MONTGOMERY COUNTY DEPARTMENT OF PARK AND PLANNING

MEMORANDUM

SITE PLAN

BUCKINGHAM TERRACE (8-04021)

BUCKINGHAM TERRACE
SITING PLAN
LOT 1 & 2 HERBERT HERRON SURVY AND OUTLOT A BUCKINGHAM TERRACE
WASHINGTON COUNTY, MARYLAND
WATCHDOG DISTRICT NO. 13

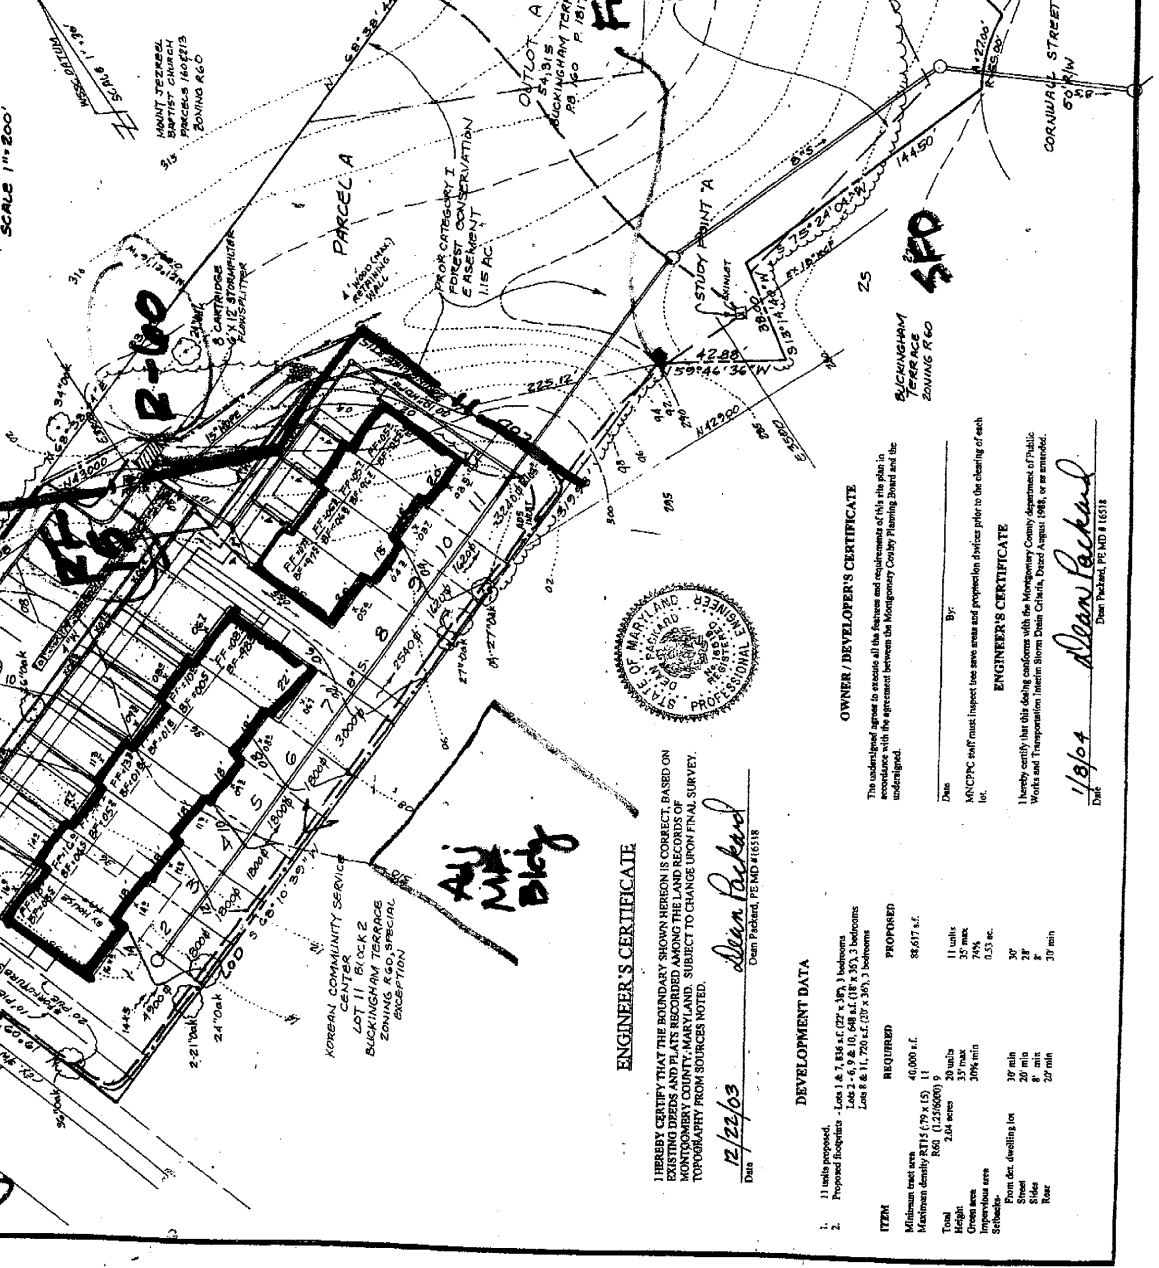
1. Lighting and Landscaping Plan
 - a. Street trees to be 40 -45 ft on center adjacent to University Boulevard.

Lighting has been provided with a 100-watt metal halide lamp on a 13-foot pole. Staff further recommends that a fourth light be added closer to the townhouses without garages.
